**RAWHIDE WASH
(AT SILVERSTONE)
SCOTTSDALE, ARIZONA**

**LETTER OF MAP REVISION
TECHNICAL DATA NOTEBOOK**

March 2013
Updated September 2013
Comment Response May, 2014
WP# 113671.02

Subject: FEMA letter dated November 20, 2013
Identifier: Silverstone Rawhide Wash LOMR
FIRM Panel: 04013C1310L
WP #113671.02

Detailed Hydraulic Cross-Sections: Plate 1, Section H, I, J, K

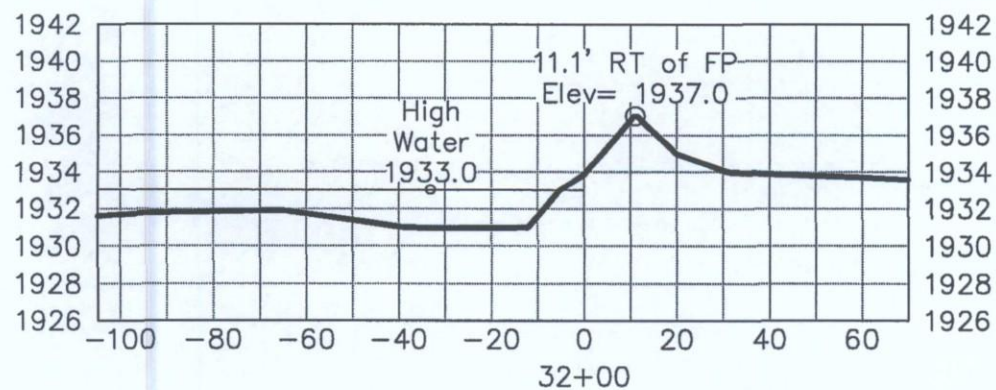
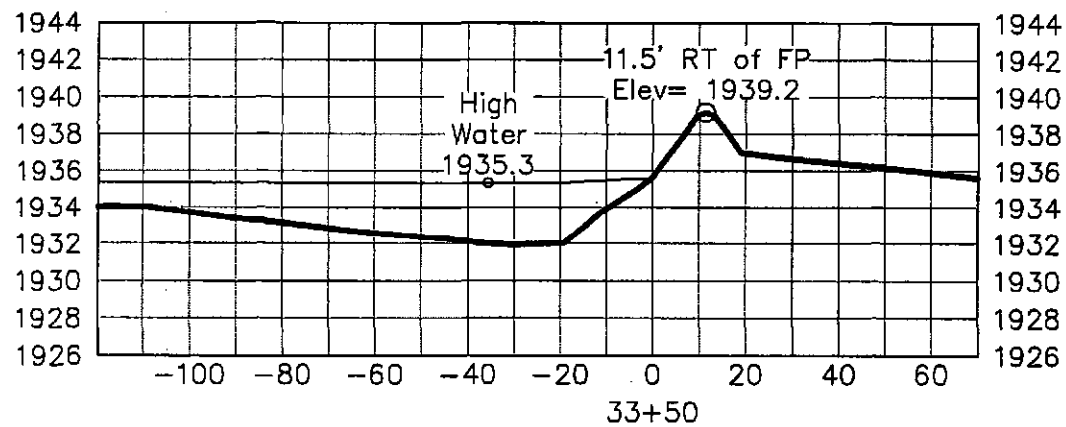
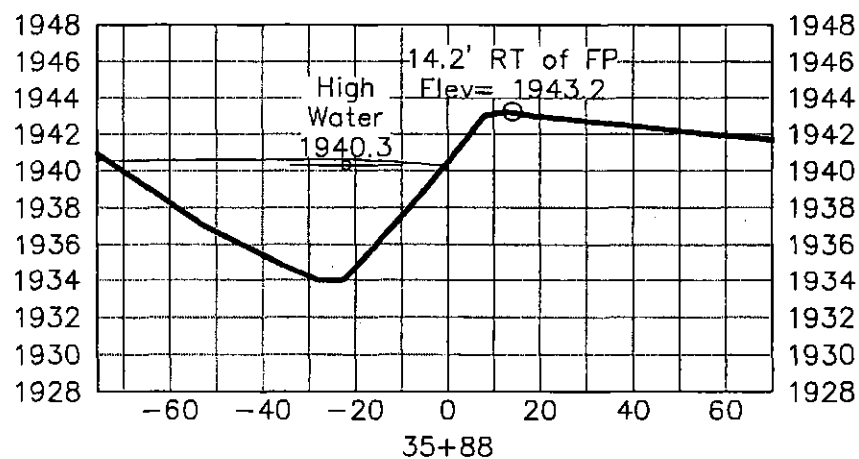
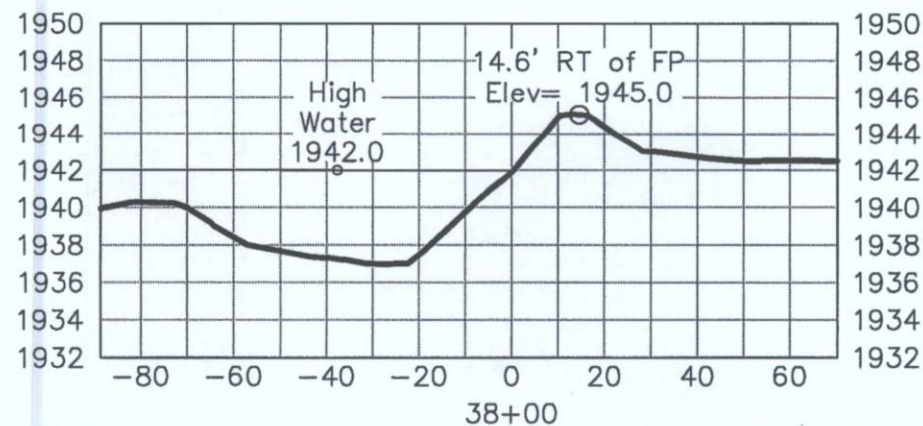
Please submit additional documentation that shows that there are no floodwalls or levee situations on the banks of the Unnamed Wash between East Pinnacle Peak Road and East Happy Valley Road. In addition, please provide certification by a registered professional engineer, certifying that no floodwalls or levee situations were incorporated into the hydraulic analysis. If floodwalls or levee situations do

exist, please state that they do not come in contact with the base (1-percent-annual-chance) flood or provide evidence that the project meets all parts of Section 65.10 of the NFIP regulations.

Response: We contacted Baker/AECOM's Lakewood office to clarify their second comment. From follow up conversations with the reviewer, we learned this comment is applied to the land features on the east side of Rawhide Wash, approximately 2,500 feet north of Pinnacle Peak Road (Area #1) and a specific location (Area #2) along Miller Road, 1,300 feet north of Pinnacle Peak Road. The following research and information documents that no floodwall or levee situation is incorporated into the hydraulic analysis. Results of the analyzed flow indicate containment occurs within the drainage corridor as depicted on the referenced Exhibit 3.

For location, see Work Map Exhibit 3, Sheet 2, Cross-Section 7490
